RE: NCSF#1

Re: **Site Development Plan Approval Application**
North Castle South Fire District No. 1
621 North Broadway
Section 122.20, Block 1, Lots 5, 6, 7

An annotated response to Kellard Sessions memo dated May 22, 2020 is provided below in red. Comments addressed by others are provided separately.

The following is an annotated response to Kellard Sessions memo dated May 22, 2020. Response noted in red, Comments addressed by others provided separately.

SHEET No
ER-2

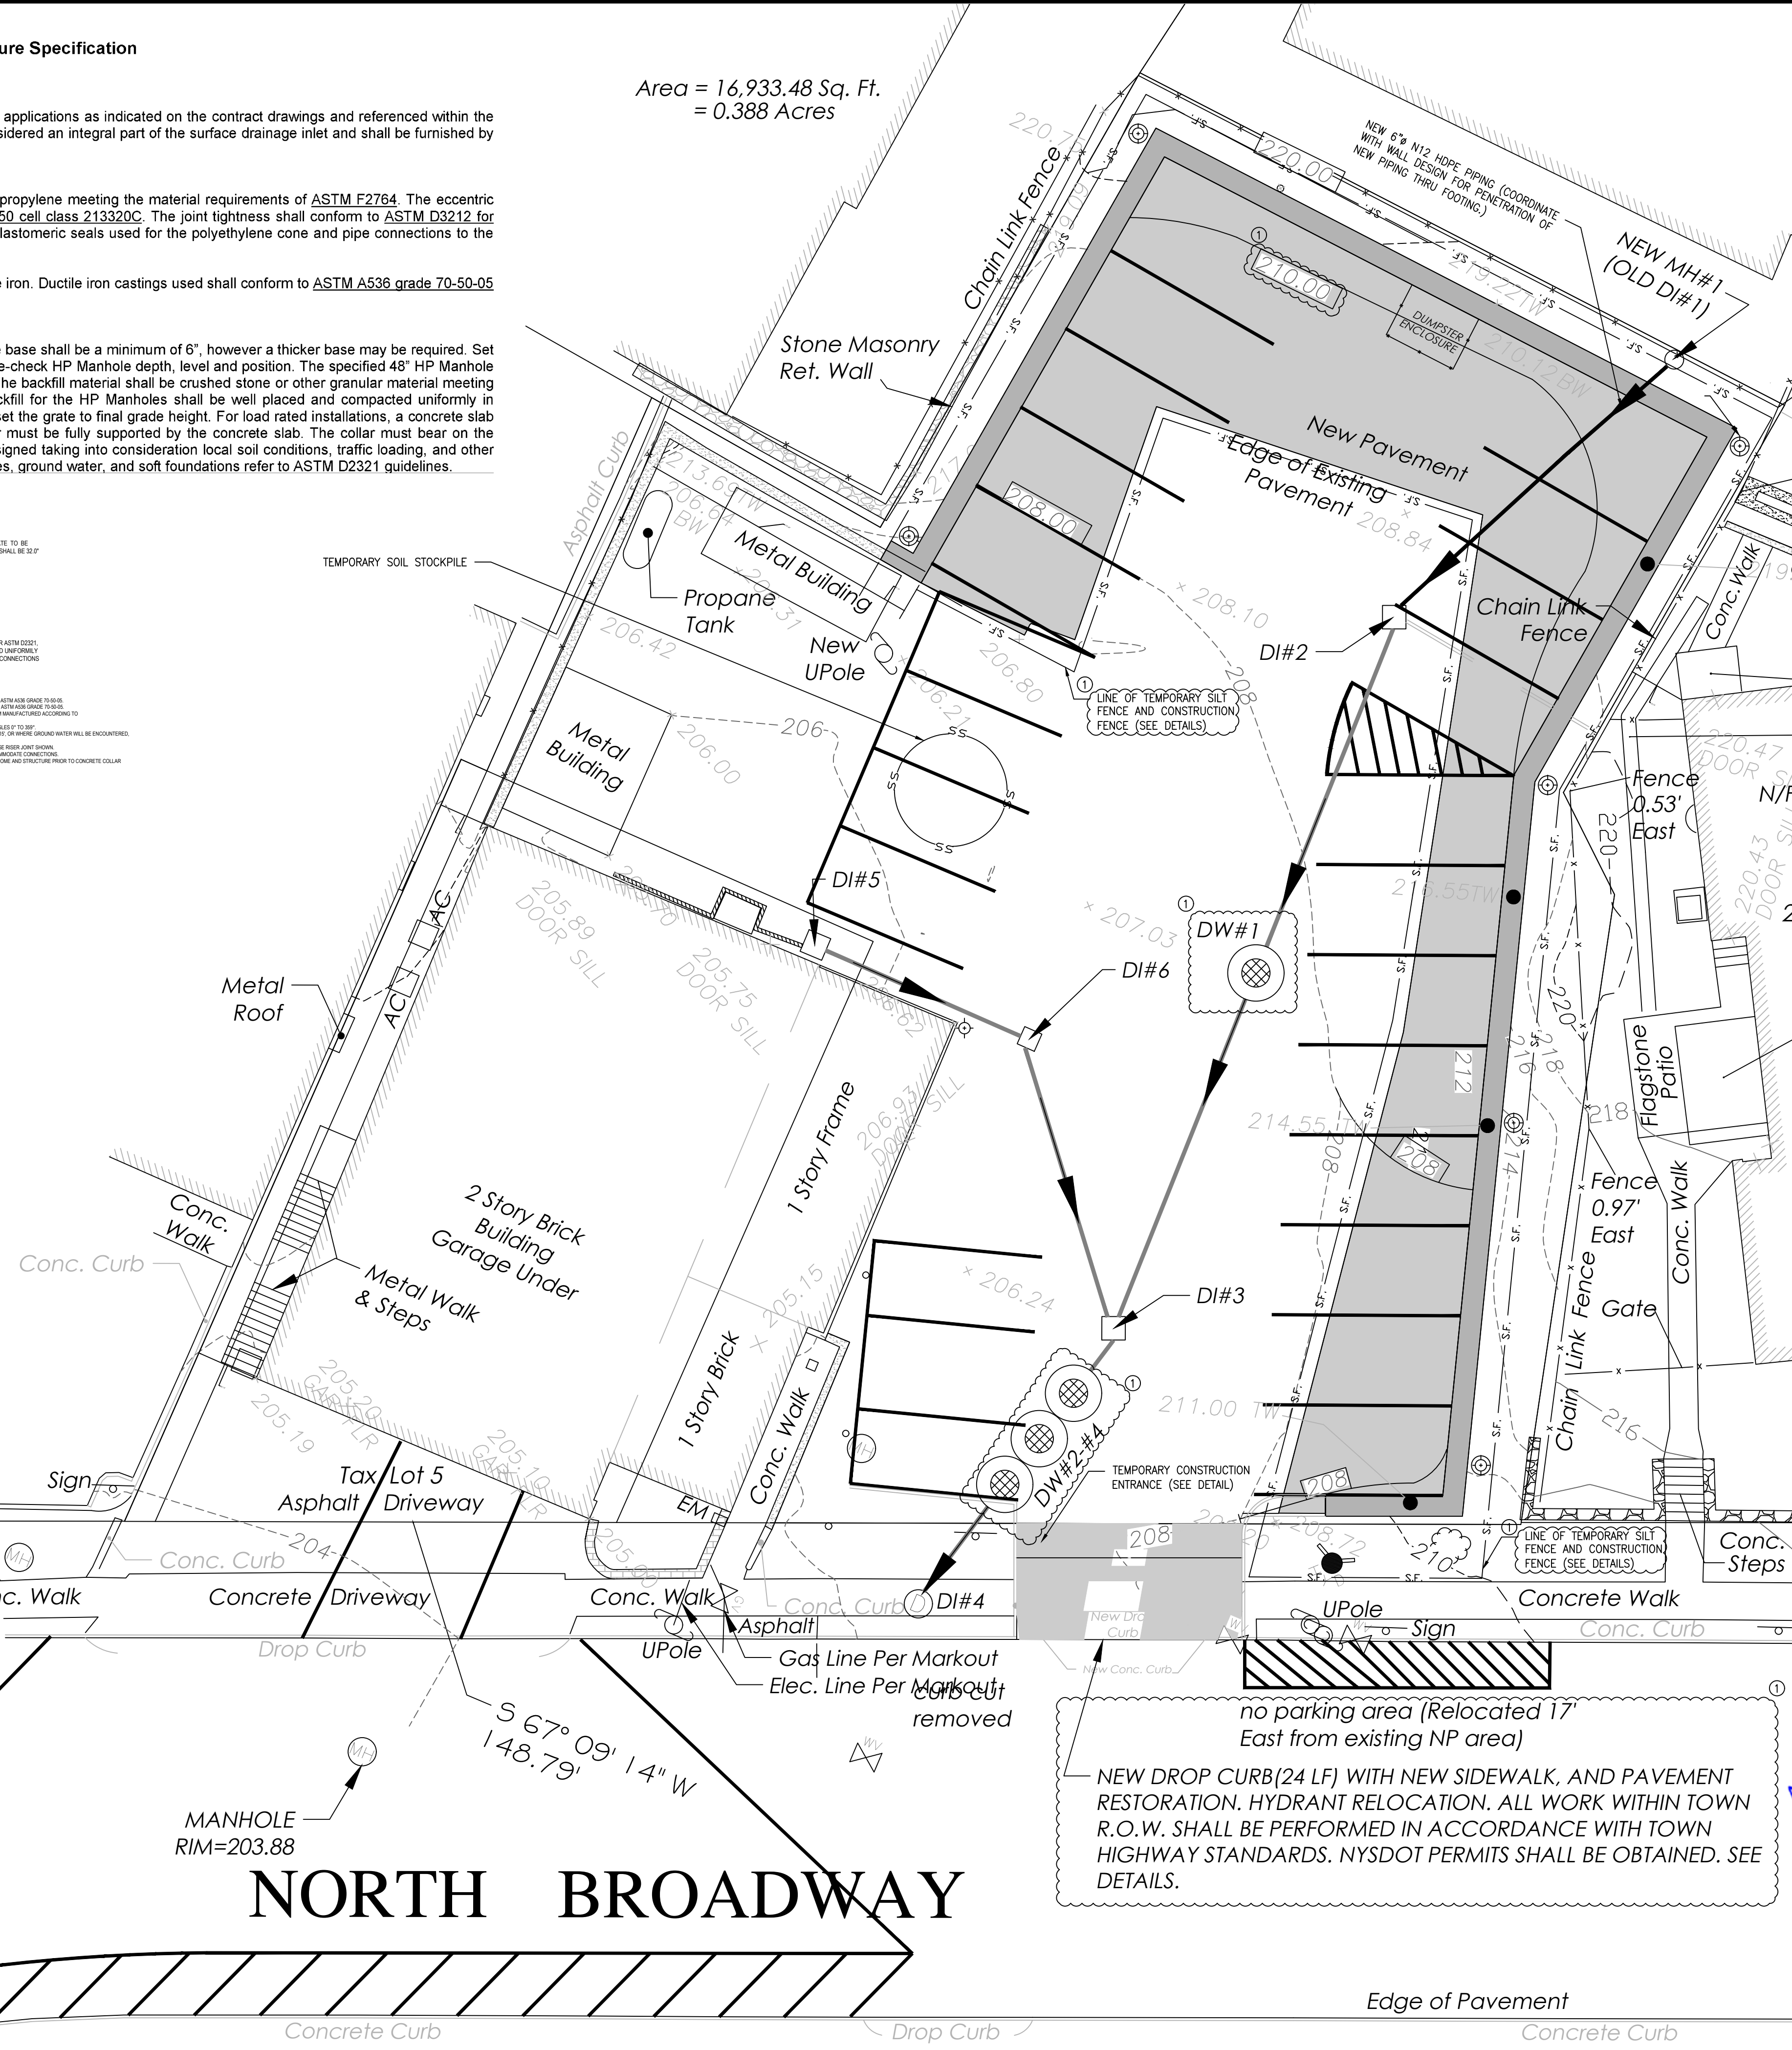
5. The site plan shall include proposed topography and spot elevations, as necessary.

8. The applicant has prepared a stormwater mitigation plan, including sizing calculations demonstrating mitigation of the net increase in runoff generated for the 25-

year storm event, as required by Town Code. In light of the above request to postpone soil testing, a conservative approach was used for soil percolation rates to be confirmed at a later date. It is understood that should the need for additional or modified drainage facilities be required as a result of the testing, a revised plan will be provided for review and approval. However, in review of the drainage plan and without the benefit of proposed grading, as requested above, it appears that the proposed drywells and their associated rim elevations are set at the high points of the parking lot. We would recommend that the applicant reconsider the layout of the proposed infiltration system to a centralized location at the downstream confluence of the existing drainage facilities. In that way stormwater runoff from the entire parking lot could be collected and mitigated in the infiltration system with an emergency overflow to the existing storm facilities in North Broadway.

TOPOGRAPHY INFORMATION HAS BEEN ADDED. SEE ER-2.

SHEET ER-2 HAS BEEN UPDATED TO REFLECT THE RELOCATION OF THE PROPOSED DRYWELL TO BE DOWN GRADIENT OF EXISTING FLOWS AS RECOMMENDED.

A-101

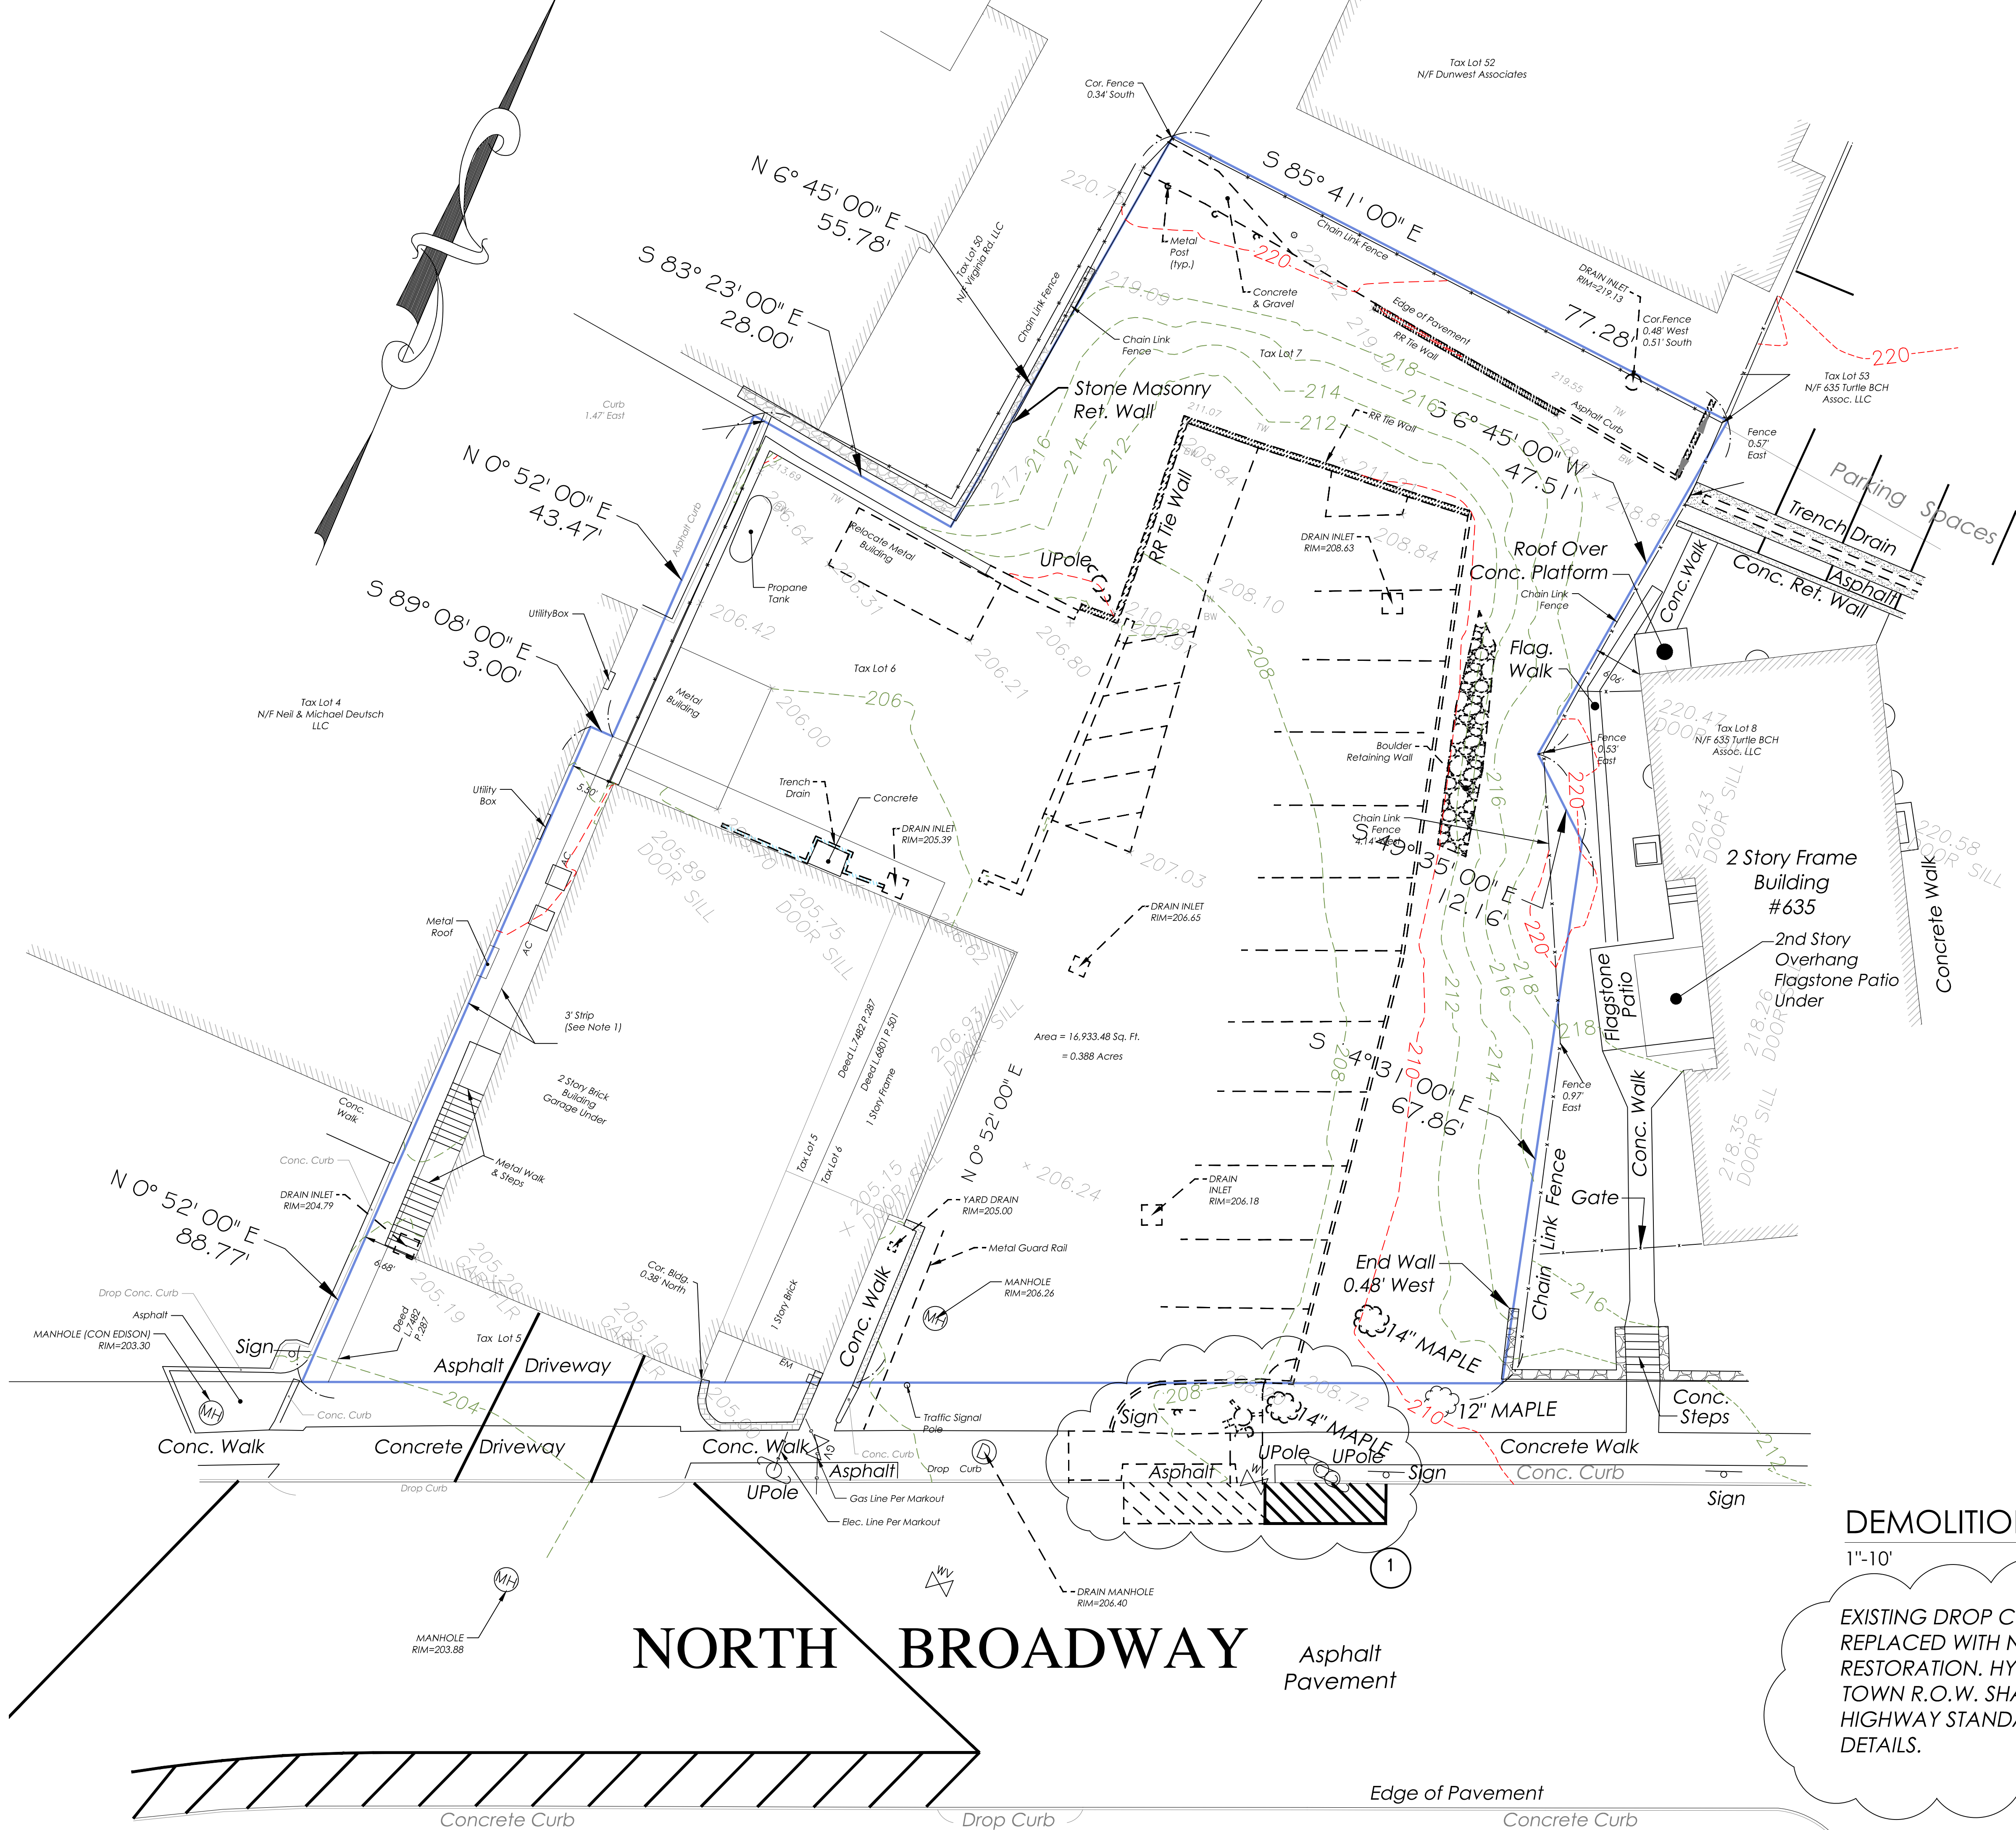
3. The plan proposes shifting the existing driveway access approximately twelve (12) feet to the east, requiring the relocation of an existing fire hydrant and the loss of one on-street parking space. The reduction in on-street parking and required revised signage should be reviewed by the Highway Department and may require approval by the Town Board. The plan should clearly illustrate the limits of removals of existing curb and sidewalk and provide details for new sidewalk, pavement restoration and hydrant relocation.

4. The plan proposes modifications to the driveway access onto North Broadway (NYS Route 22). The applicant will be required to obtain driveway access permits from the New York State Department of Transportation (NYSDOT).

NOTATIONS HAVE BEEN ADDED TO THE PLAN TO REFLECT LIMITS OF NEW CURBING, ETC.

A REFERENCE TO REQUIRING A NYSDOT PERMIT HAS BEEN ADDED TO THE PLAN.

EXISTING DROP CURB. APPROX. 29 LF TO BE REMOVED AND REPLACED WITH NEW CONCRETE CURB, SIDEWALK, AND PAVEMENT RESTORATION. HYDRANT RELOCATION AND ALL WORK WITHIN TOWN R.O.W. SHALL BE PERFORMED IN ACCORDANCE WITH TOWN HIGHWAY STANDARDS. NYSDOT PERMITS SHALL BE OBTAINED. SEE DETAILS.
